# CAUTION NOTICE

DB500-PCN-3

## COBRA High Pressure Supply Hose DB5002918

FIGURE 1

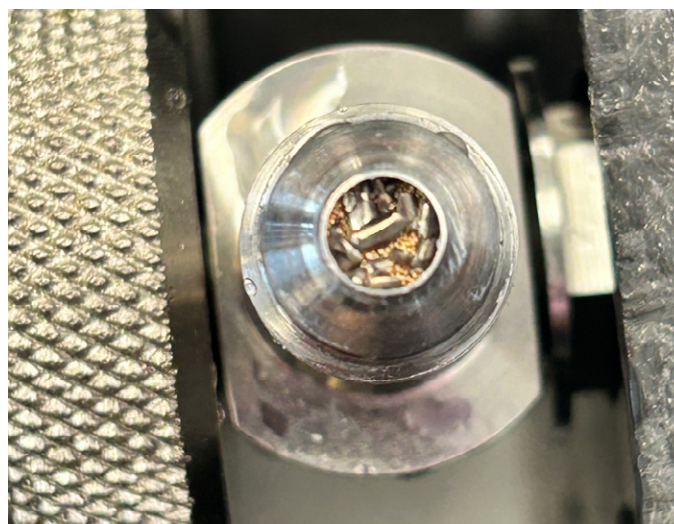
JFD have identified a batch of these hoses with defective electroless nickel plating on the 5/16" threaded fitting. The plating has been observed to be insufficiently bonded to the inside surface of the fitting. The plating has subsequently detached from the fitting and been captured by the filter at the 2-stage regulator inlet. In extreme cases, it is possible that this could cause a flow restriction of gas into the COBRA set.

- Remove the hose from the COBRA set.
- Inspect the 2-stage regulator filter, remove any debris. If there is any doubt regarding filter cleanliness, replace the HP swivel.
- If replacement hoses are available, fit a replacement hose.
- If no replacement hose is available, insert the shank of a 1mm drill into the 5/16" hose end to dislodge any loose plating.
- Clean the hose for O2/breathing gas service as appropriate and fully dry.
- Replace hose and perform the flow test from the bench dive procedure.
- Change hose when replacements are available.
- Return hose to JFD for replacement.
